County of Santa Clara

STAFF REPORT Zoning Administration January 14, 2020

File: PLN20-159

Variance to Reduce a Side Yard Setback & Eliminate Parking

BOUNDARY & TOPOGRAPHIC SURVEY 22150 CLOVERLY CT 326-12-044

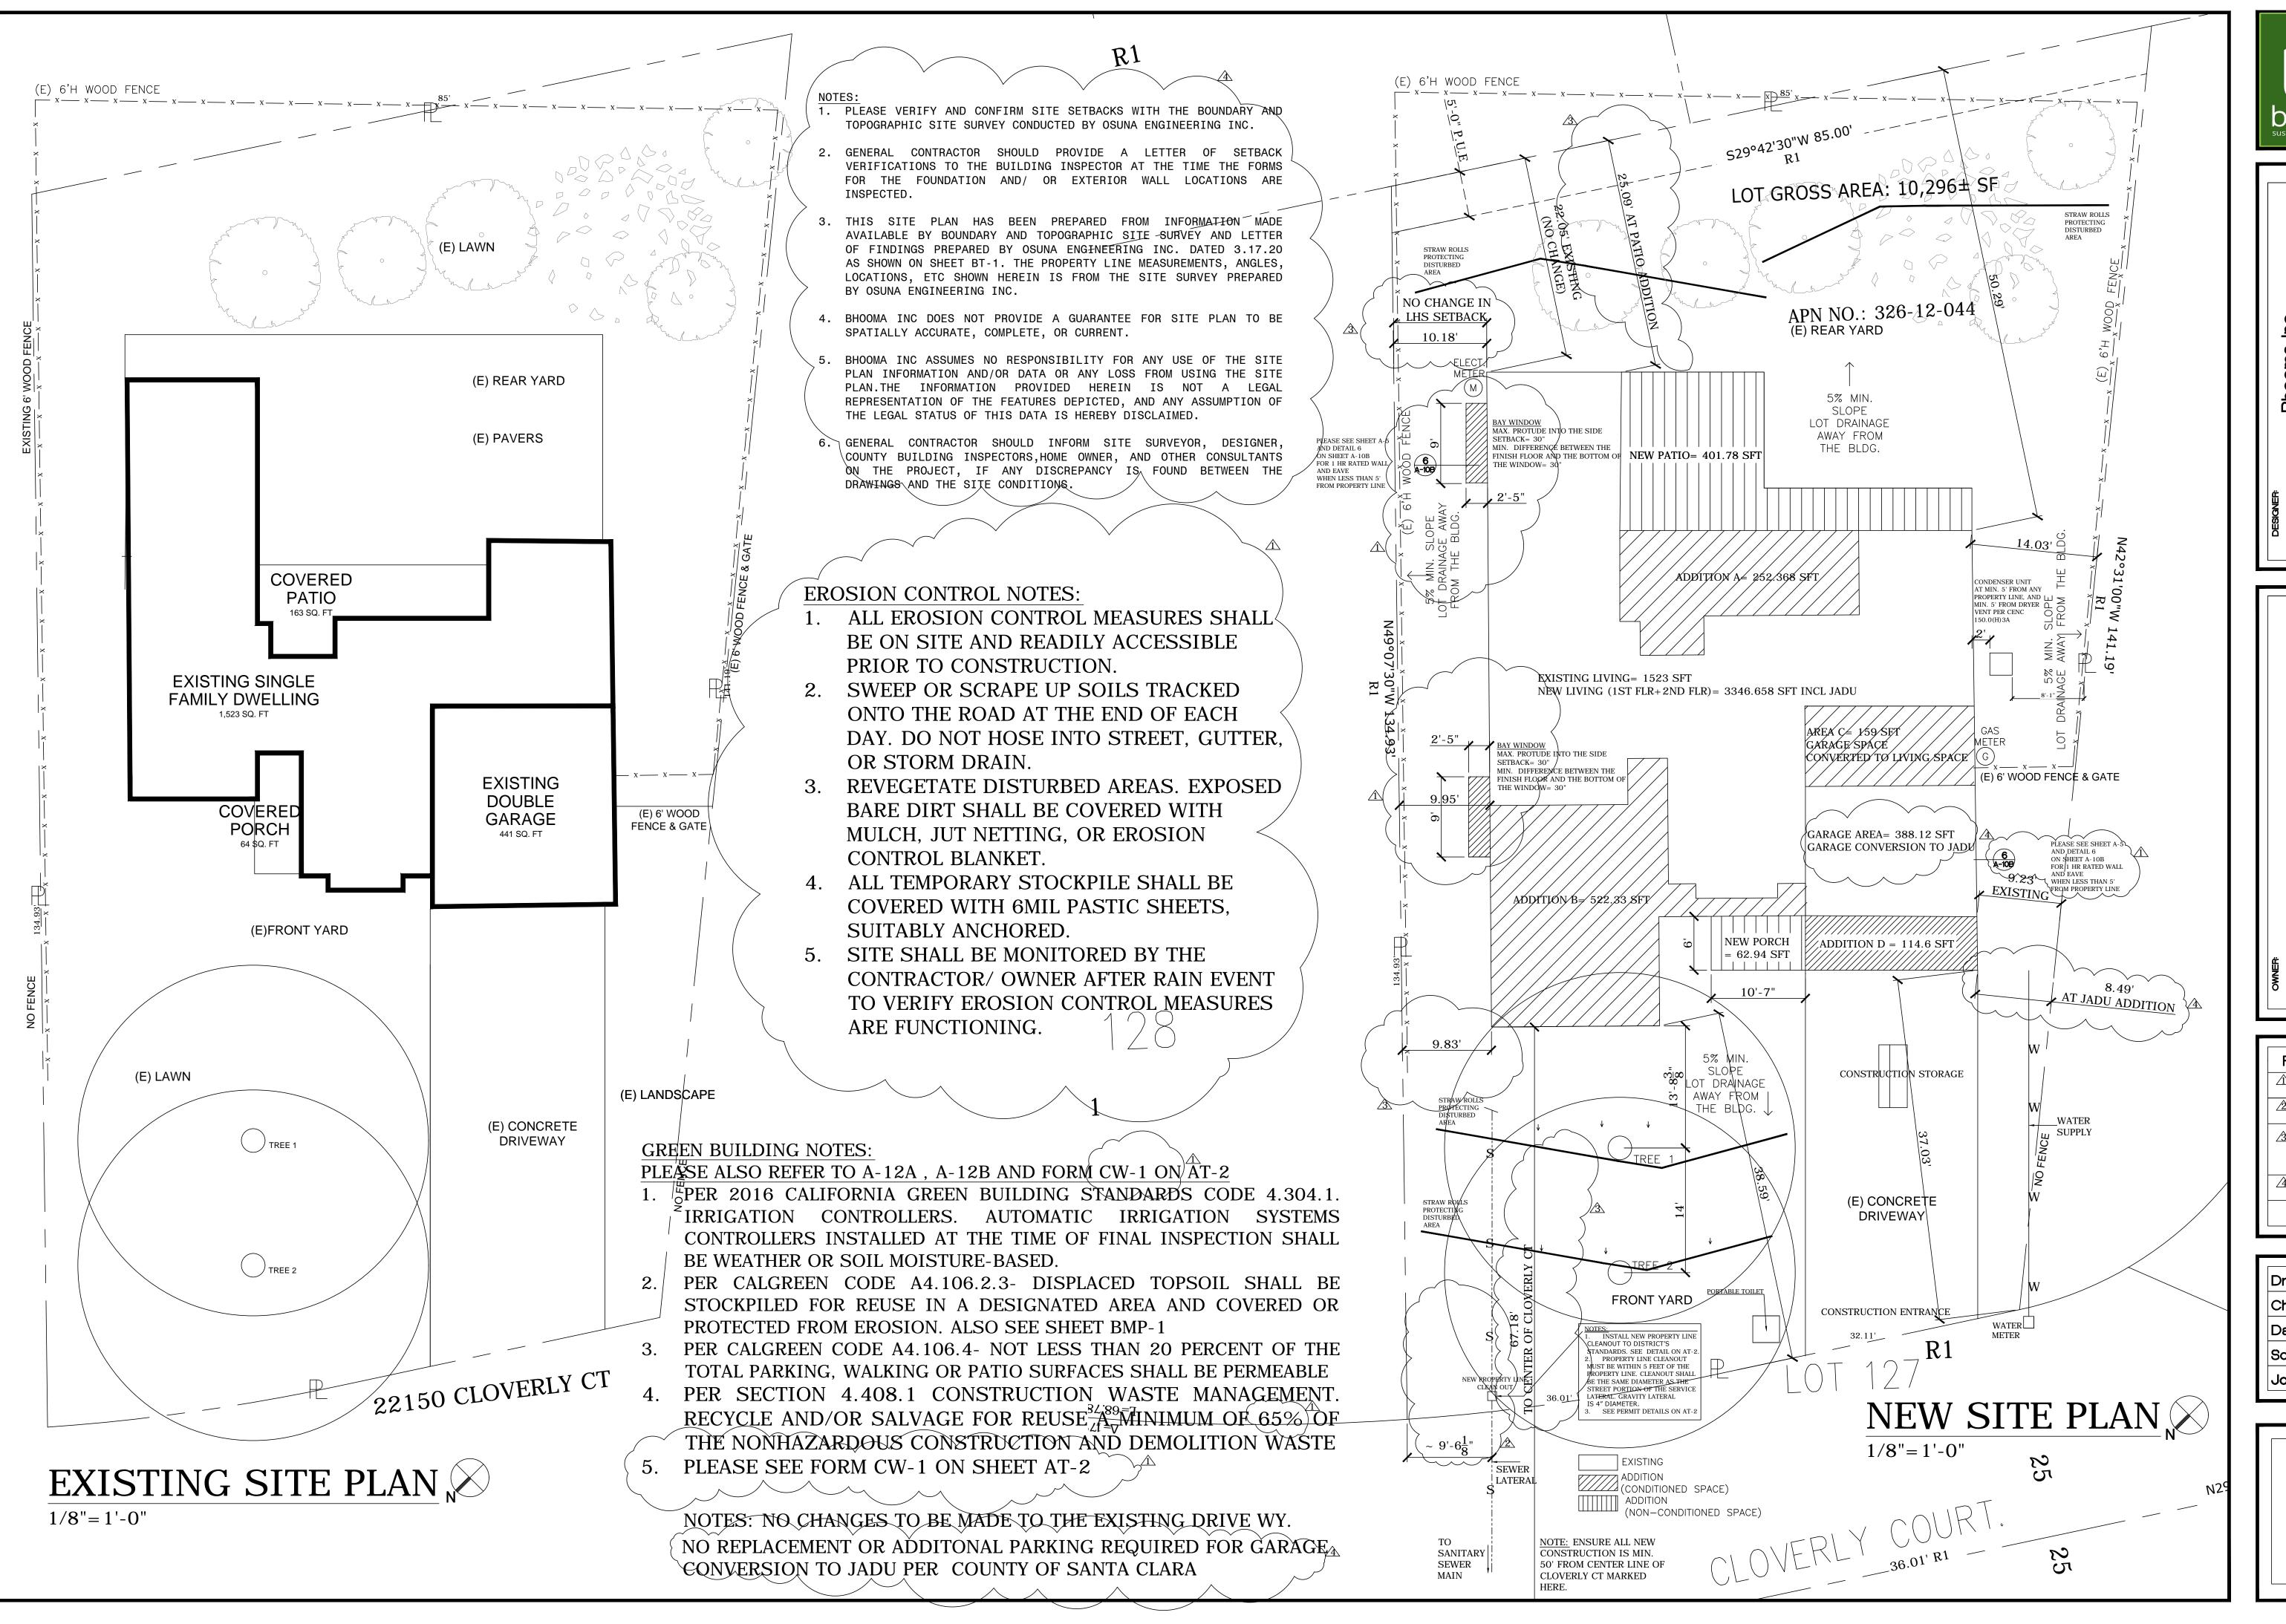
- The survey on Sheet BT-1 does not have the measurement required by the County to certify the location of construction on the property in relation to the property lines. Additionally, the survey in the plan check (Sheet BT-1) is inconsistent with the survey submitted in the application for a Variance. Please clarify the discrepancies.
